TO : All Bidders  
FROM : George M. Wiens  
PROJECT : CTE Classroom Addition  
Vista Murrieta High School  
1615400.41  
SUBJECT : Addendum 2  
DSA : 04-115755 / 33-H18

Addenda No. 2 – Scope of Work Questions

DRAWING NUMBER: **AW7.2**

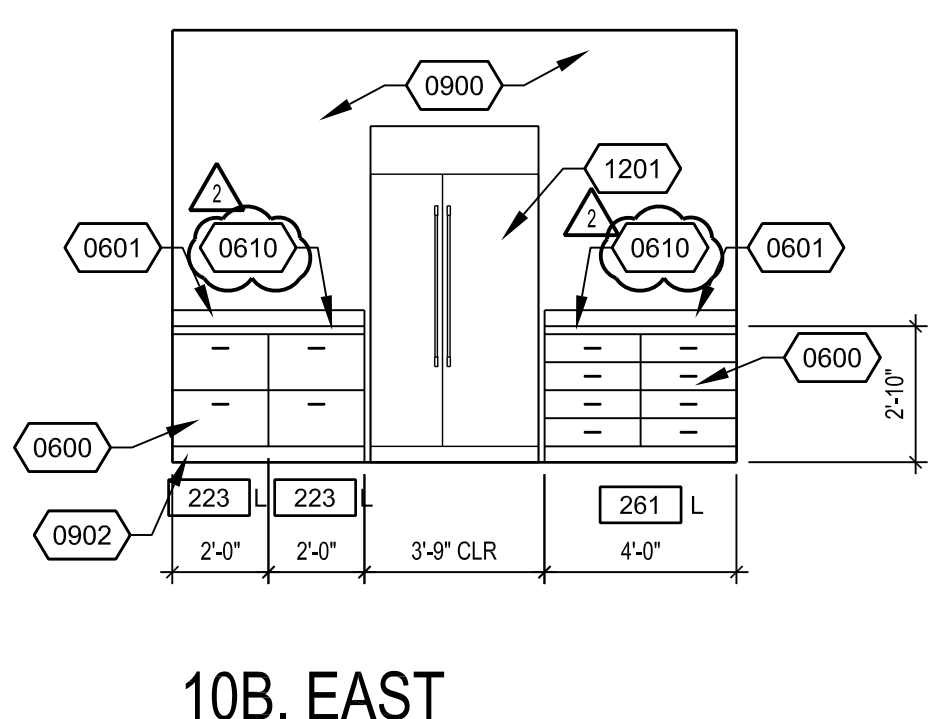
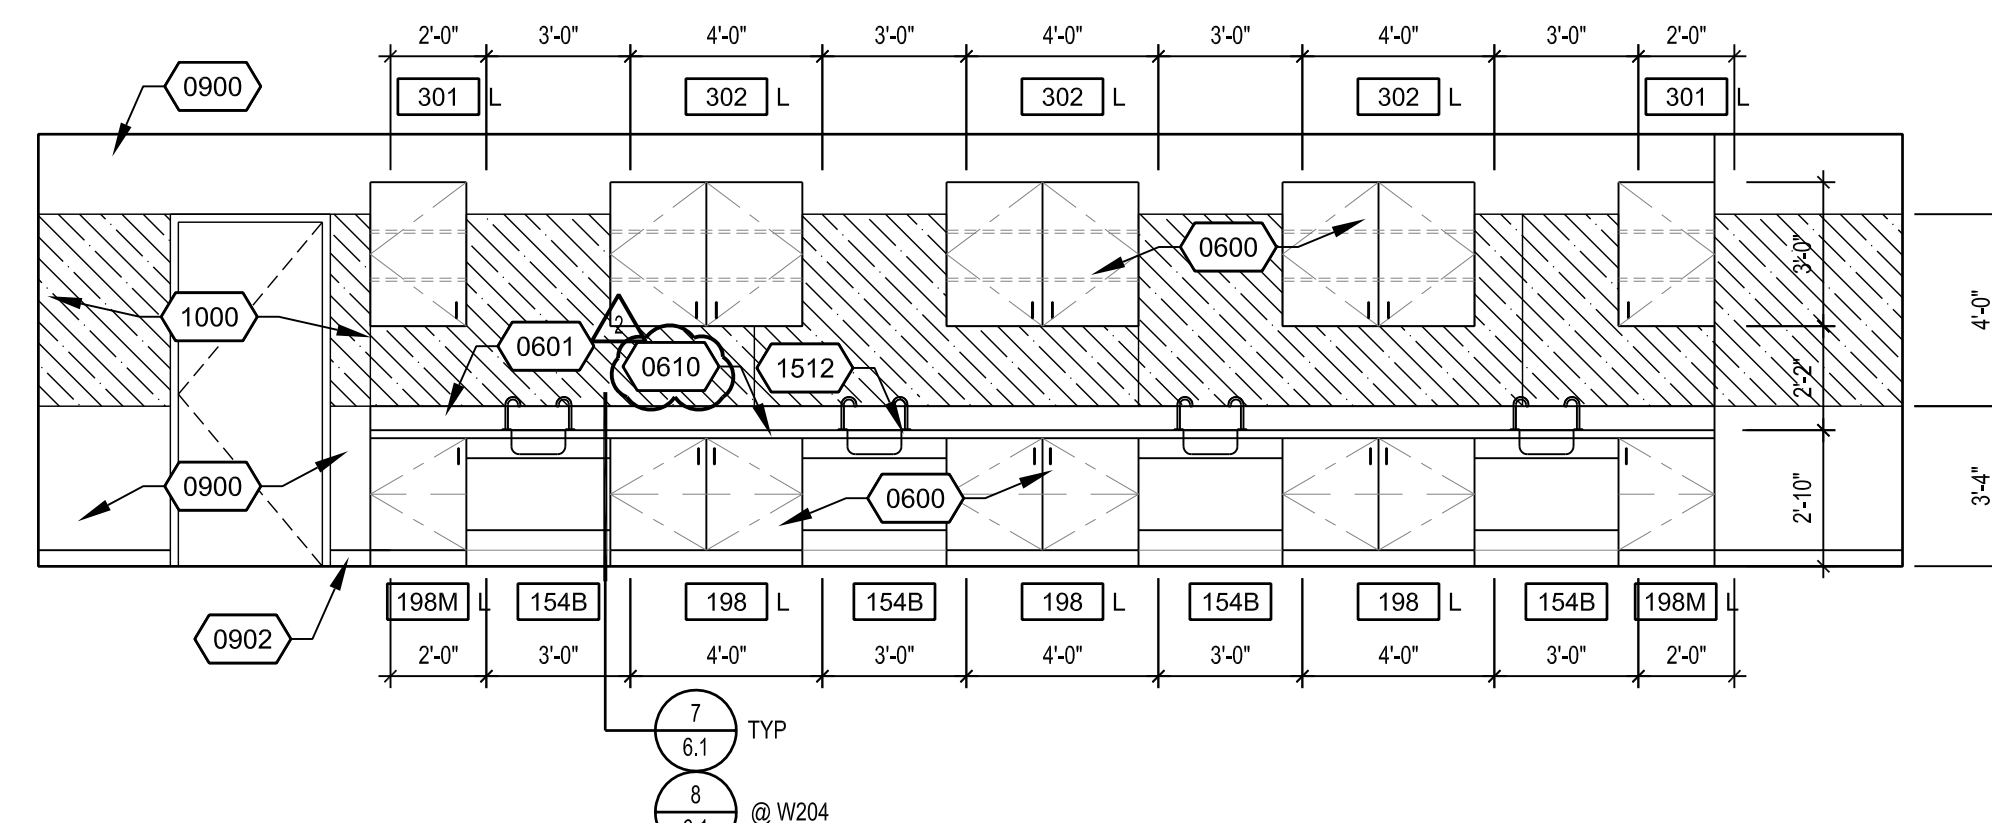
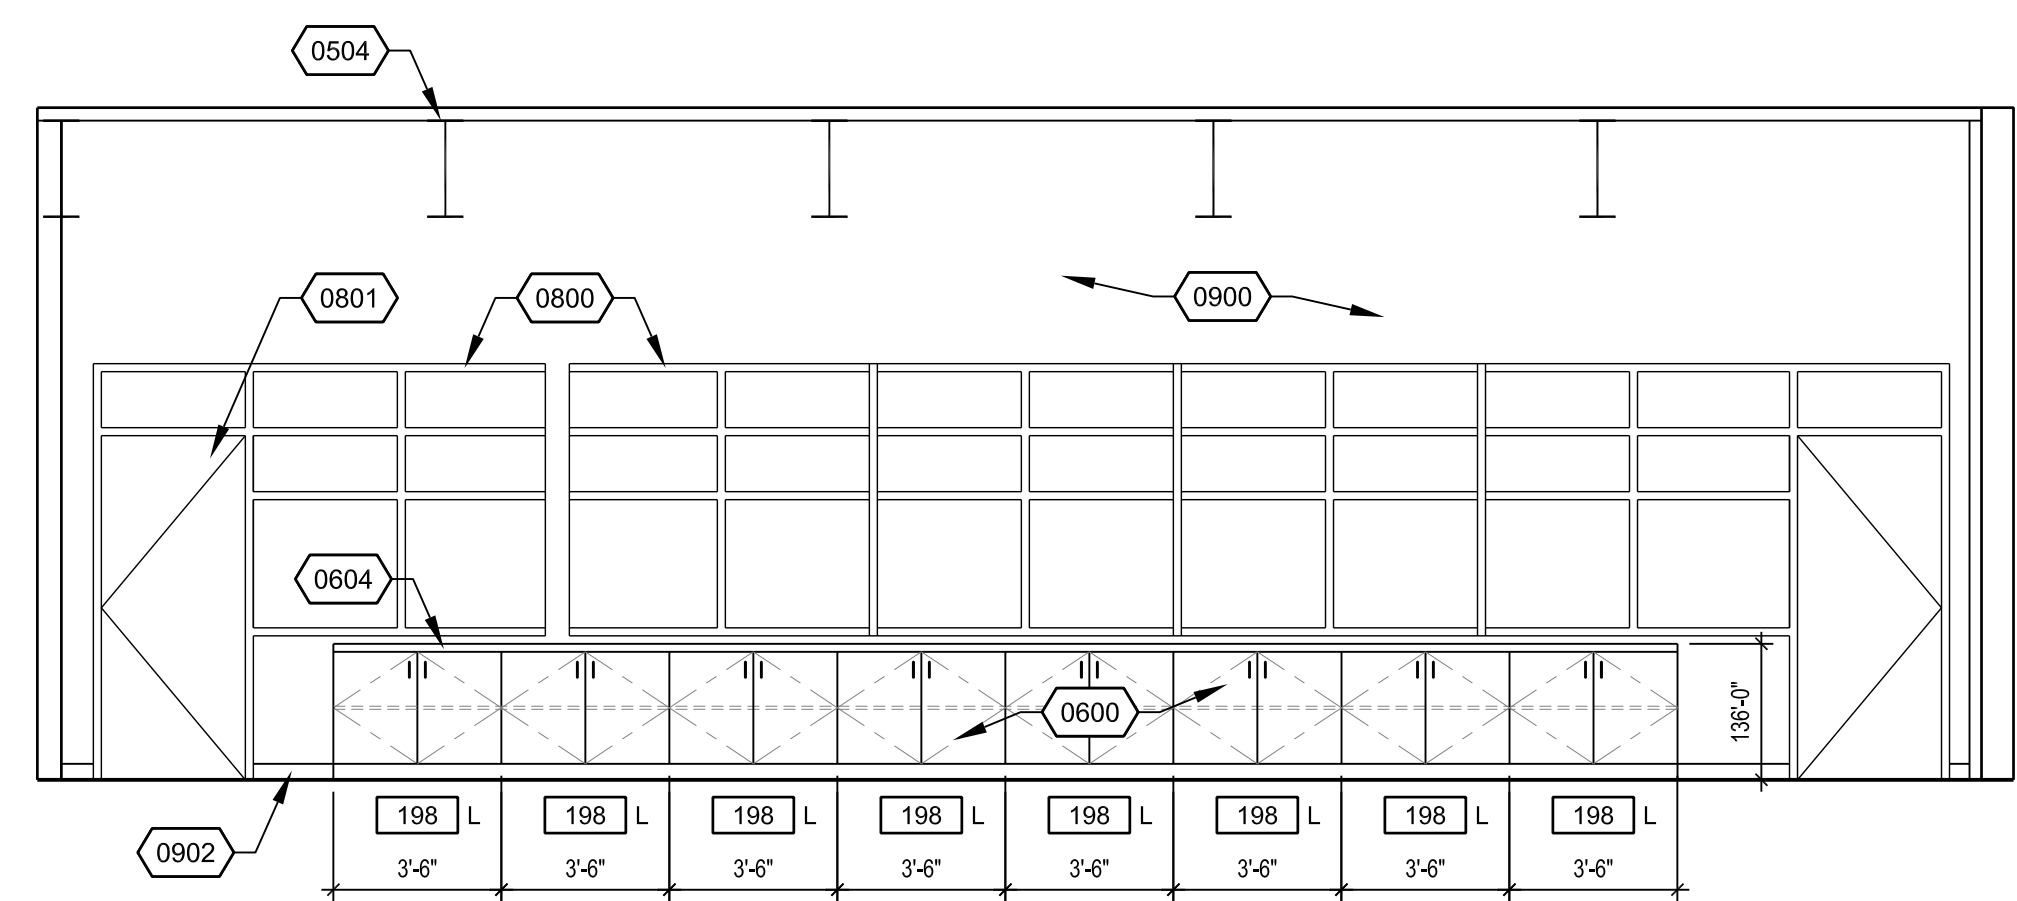
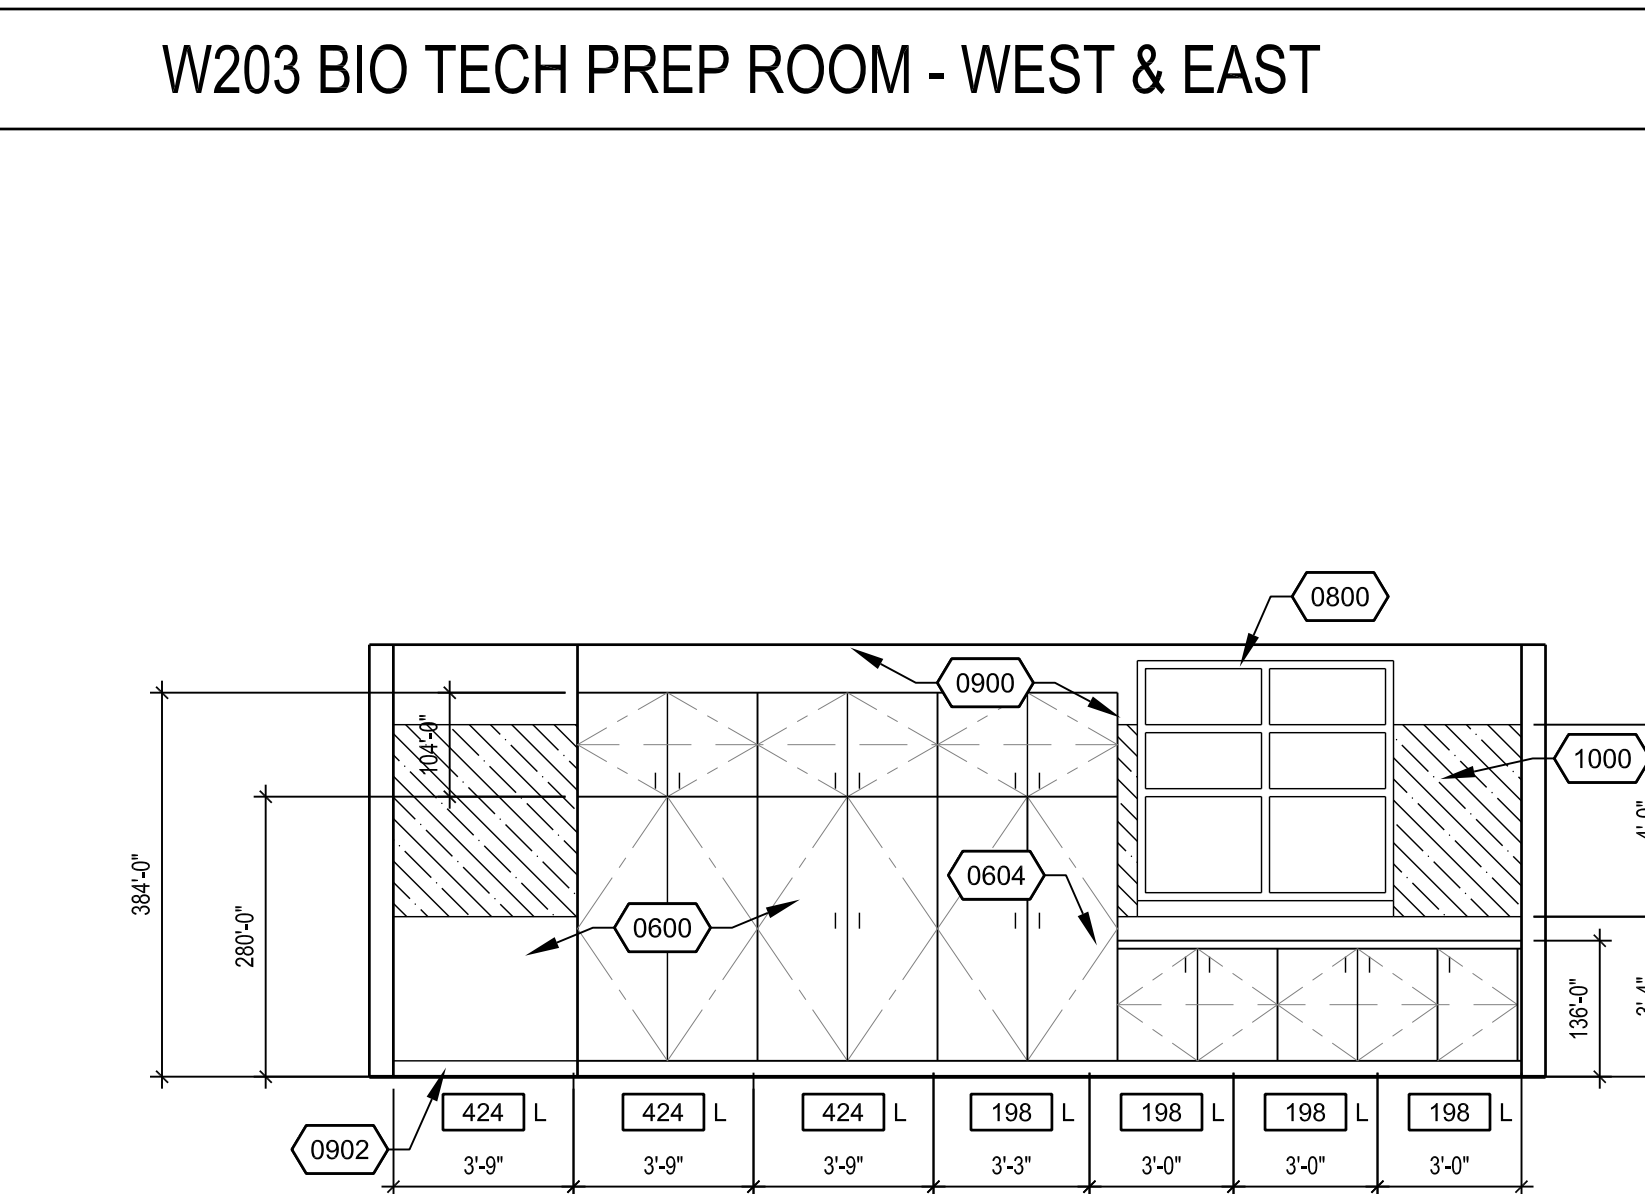
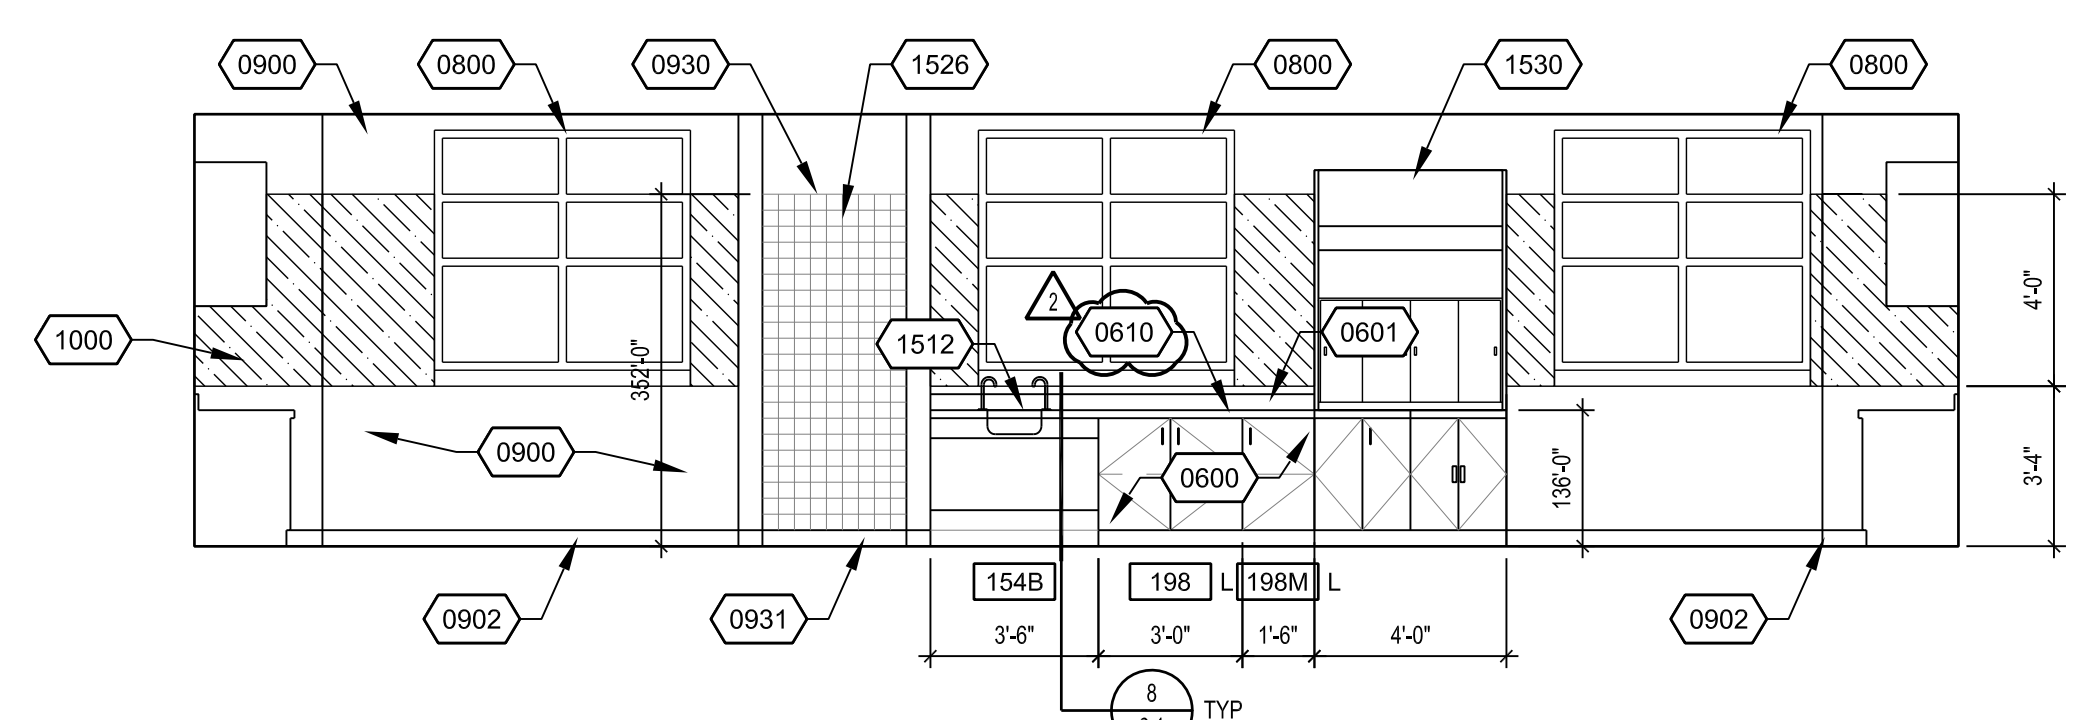
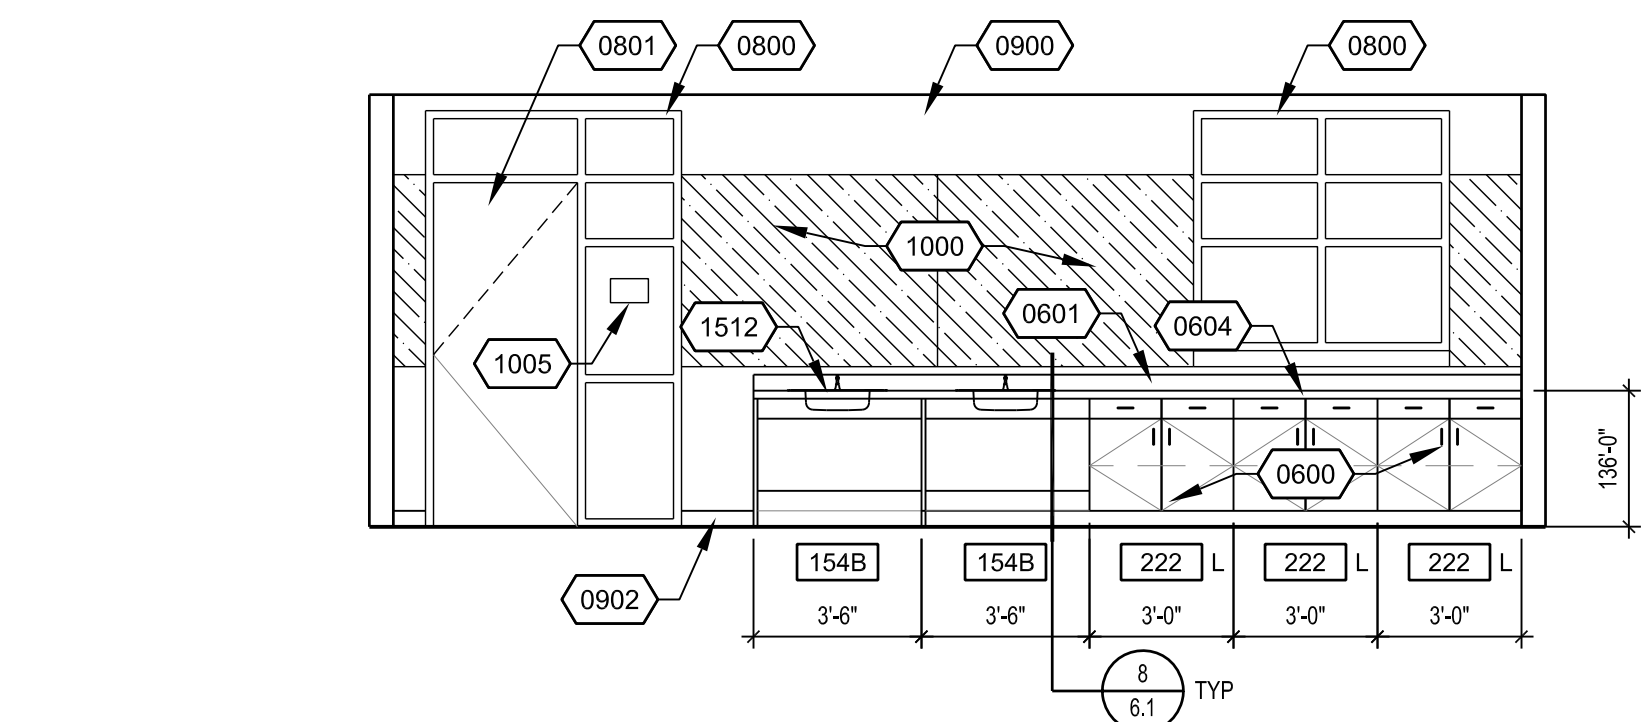
- A. Revise as indicated in the clouded area labeled Delta 2 on the attached AW7.2.
